**RECORD DRAWING REVISIONS**

**TOWN OF SHELburne**  
**SEWER/WATER RELOCATION (AOT WORK)**  
**PLAN AND PROFILE**  
**STA. 345+00 TO 351+00**

**C-19**

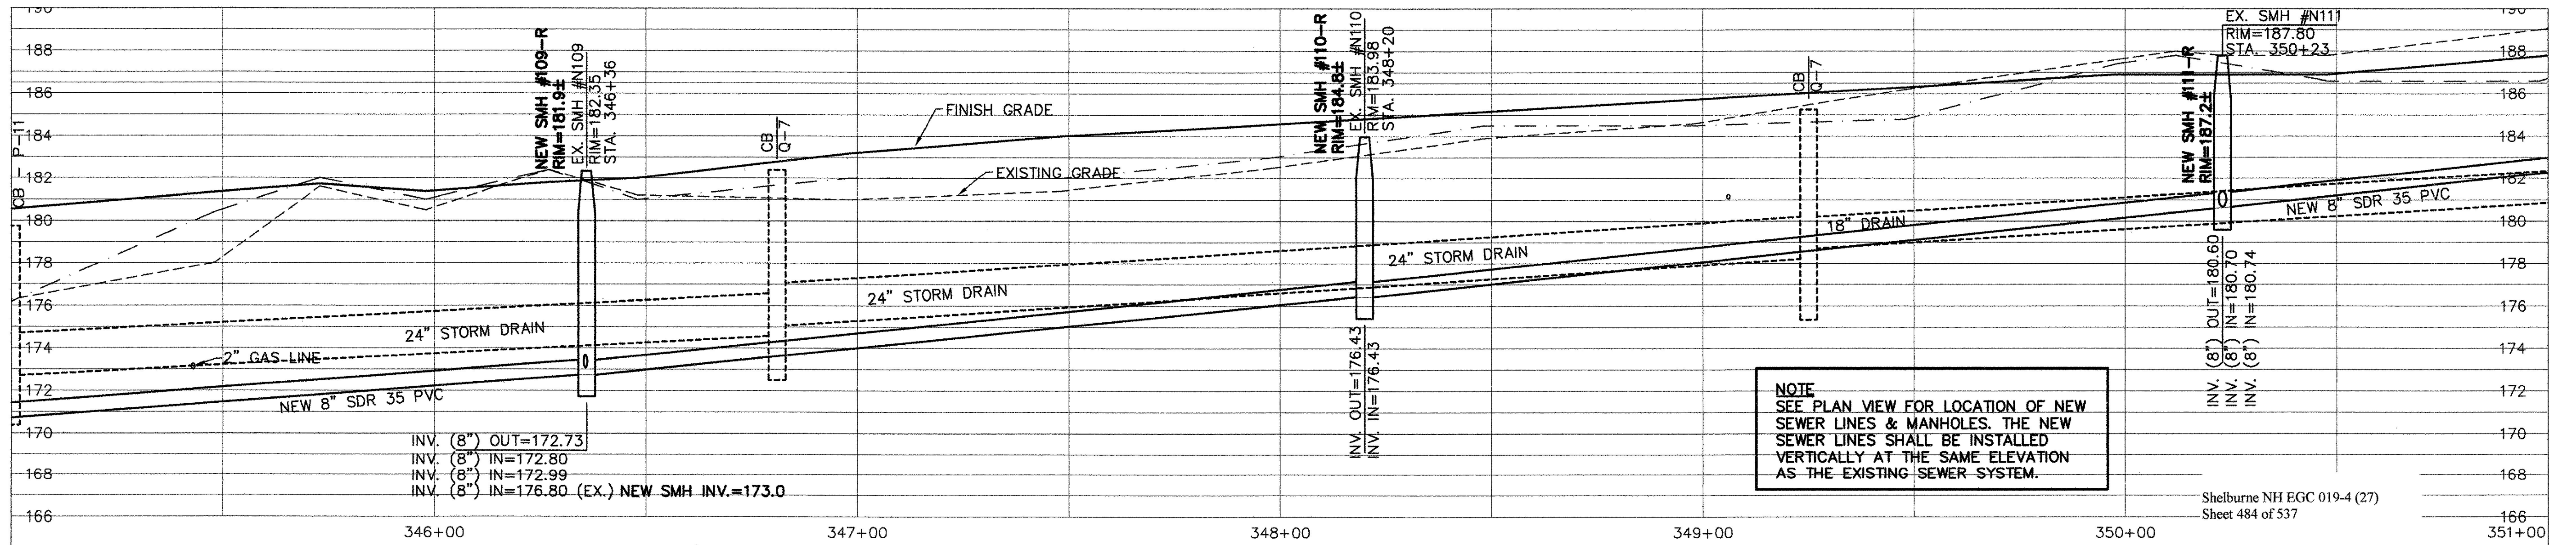
NO.	DATE	DESCRIPTION
1.	11/10/09	FIELD MARK UPS ADDED TO THE PLANS
